# Rezoning Transportation Analysis

Petition Number: #2022-006

**From:** Jake Carpenter, PE

Date	Description
06-23-22	First Review (PDM)
07-20-22	Second Review (PDM)
09-28-22	Third Review (PDM)

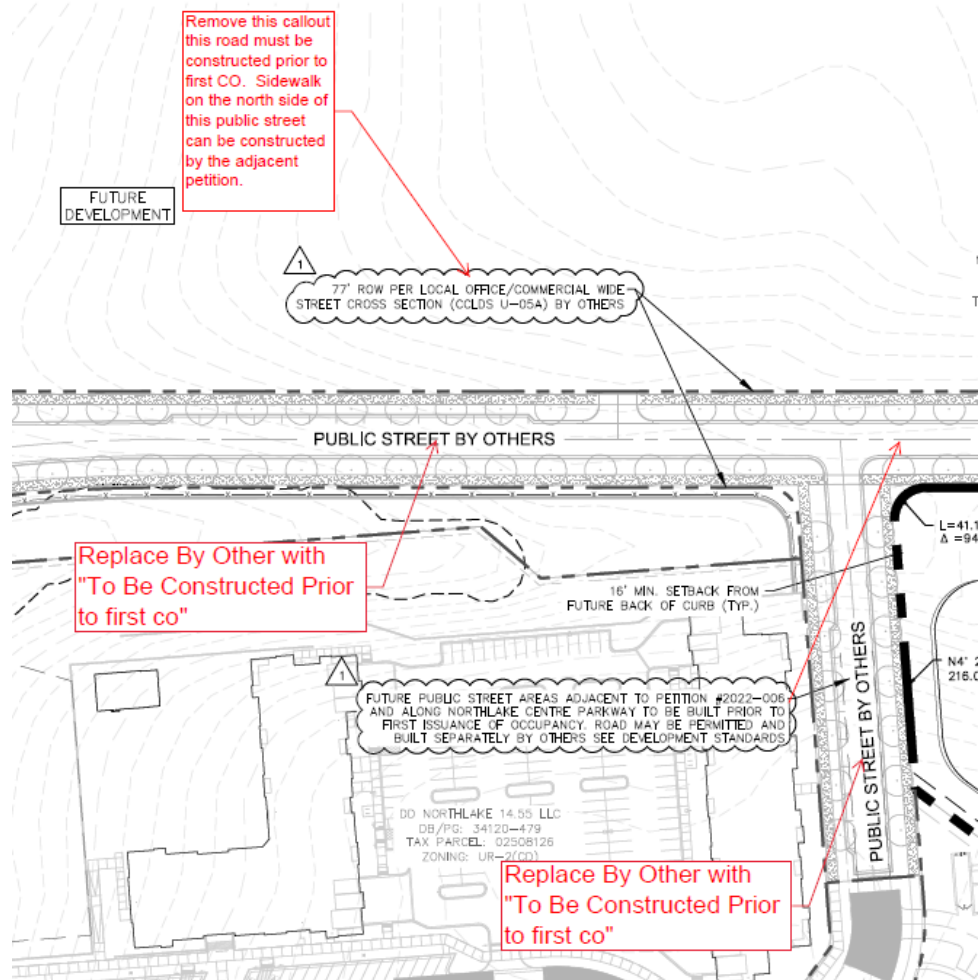
3. ~~**Outstanding Comment from 06-23-22:** Revise site plan and conditional note(s) to commit to installing both public streets that are identified as "public street by others" on the site plan. A new access location on Northlake Centre Parkway will be required by CDOT for this petition. Coordinate roadway responsibilities with RZP 2022-010 as necessary.~~

~~**Clarifying Comment (07-20-22):** Remove "By Others" from the proposed public roadways and adjust callout for street installation commitments to include both public roads.~~

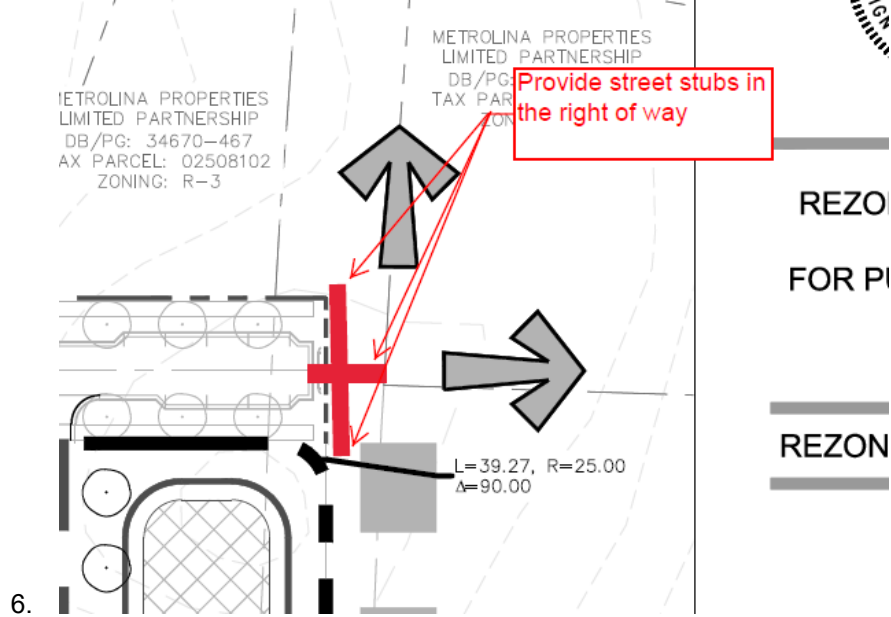
- ~~4. Outstanding Comment from 06-23-22:~~ Revise site plan and conditional note(s) to commit to dedicate 38.5 right-of-way from the road centerline of each public street. The site plan shall label and dimension the right-of-way from the road centerline.
- ~~5. Comment Rescinded 09-28-22:~~ Revise site plan to stub the proposed street within the existing ROW for future development.

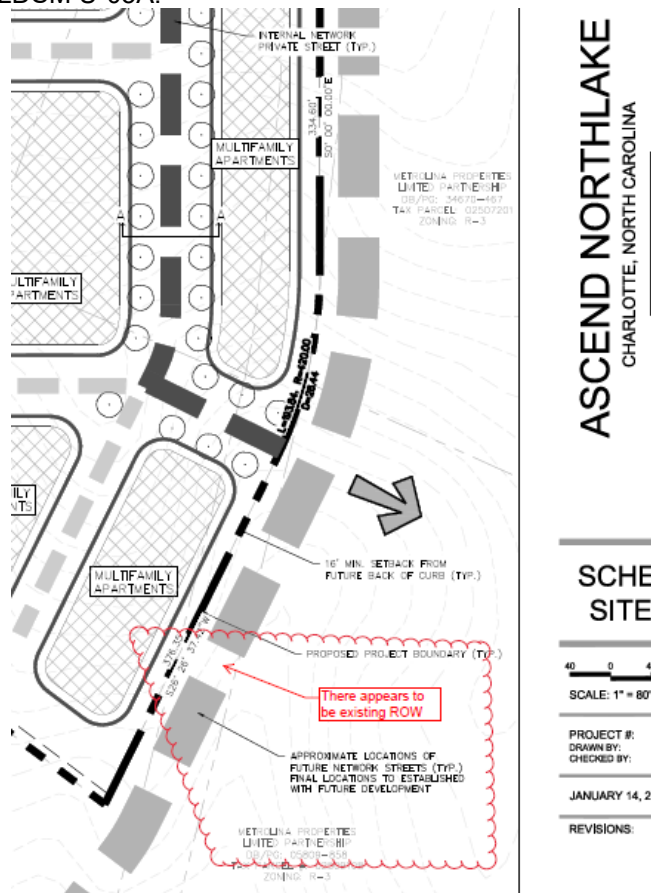
7. ~~Comment Rescinded 09-28-22:~~ Revise site plan and conditional notes to reconcile the existing versus proposed ROW along the east side of the property. The future street alignment should fall within existing ROW. Verify ROW width and provide any additional ROW required for a commercial wide roadway section per CLDSM U-05A.
